SEWAGE DISPOSAL SYSTEM

MARYLAND STATE DEPARTMENT OF HEALTH

HOWARD COUNTY

SUBDIVISION _____ ROAD 8042 Guilford Road LOT _____

PERMIT CARD

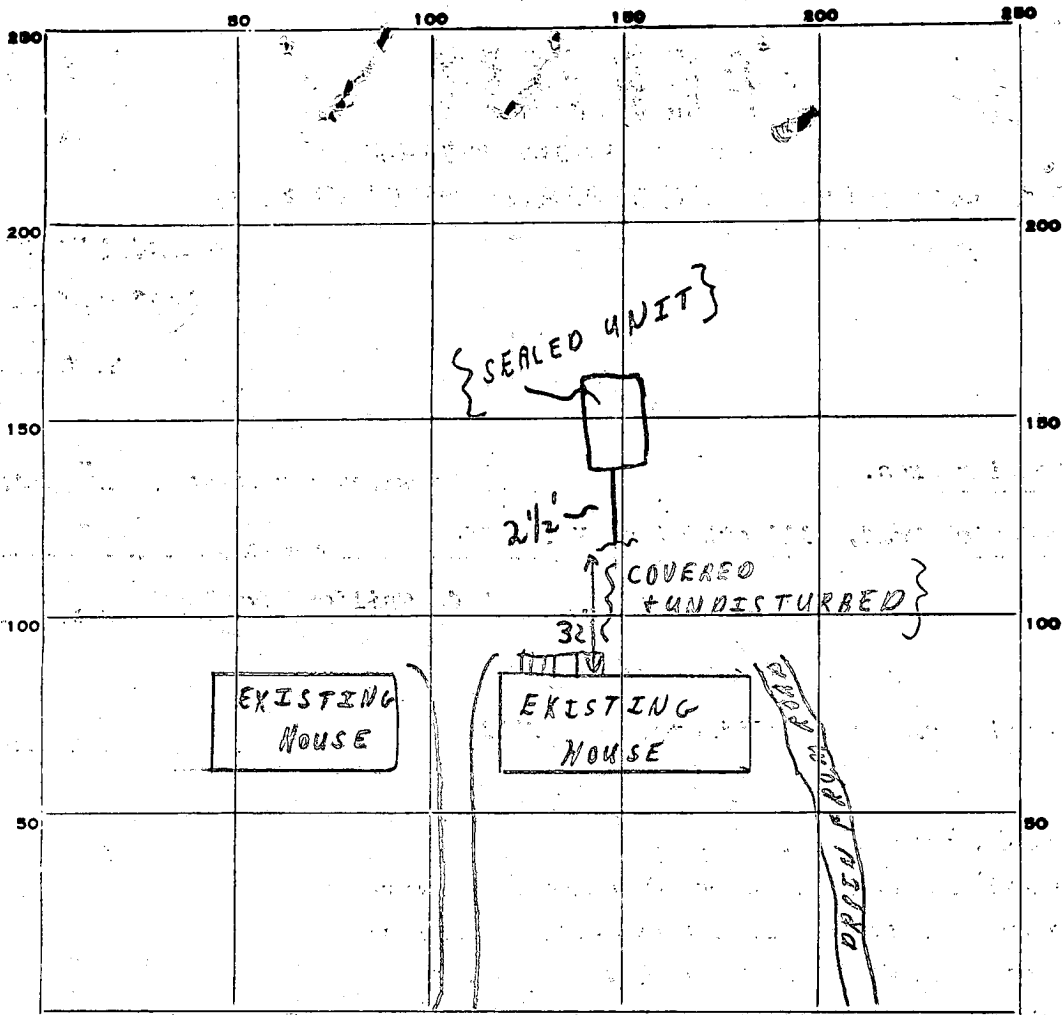
REPAIR - Sealed unit - 2000 gallons (2) Mechanical and/or electrical alarm float.
(3) Location - 45 feet more or less from left rear corner of existing building when facing lot from Route 32; in area of perc hold (3&4) and 25 feet to left of existing septic system which is overflowing.

REMARKS 4/1/81 (1) CHECKED - SEALED UNIT NOT AT SITE 10:52. C.B.C.
 (2) SYSTEM IN. 5/14/81

FIELD SHEET

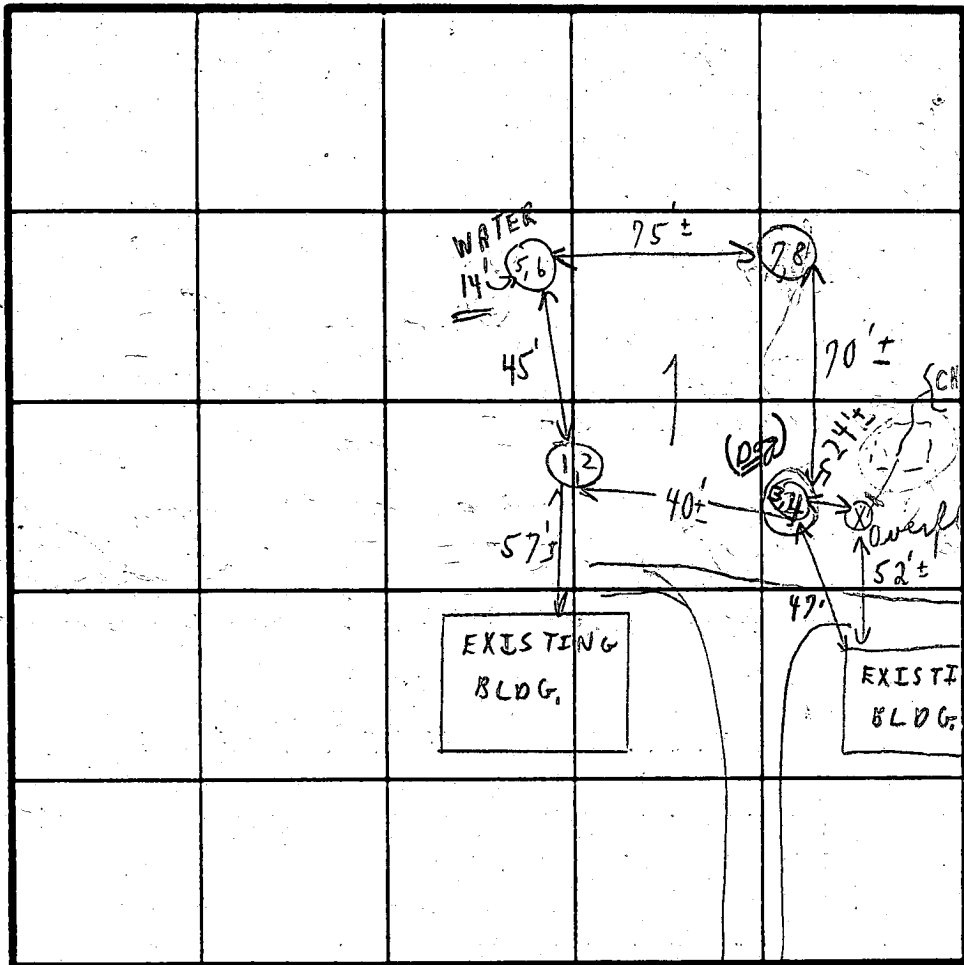
REASONS FOR REJECTION OR HOLDING 3/27/81 PLUMBING IN HOUSE; PUBLIC WATER PER MR. W. TAYLOR.

RENTER. 3/30/81 discussed - sealed unit 2,000 gallon tank (alarm device) + contract with sewerage
mechanical float + for electric before permit released F.F. & C.B.

[EXISTING HOUSE + PLUMBING] } HOLD + CHECK
TESTS BEHIND HOUSES } PROPERTY OWNER
HOLD - POSSIBLY SEALED UNIT + PLAT'S
SOIL DAMP IN ALL (ALLEN'S - KEN ALLEN)
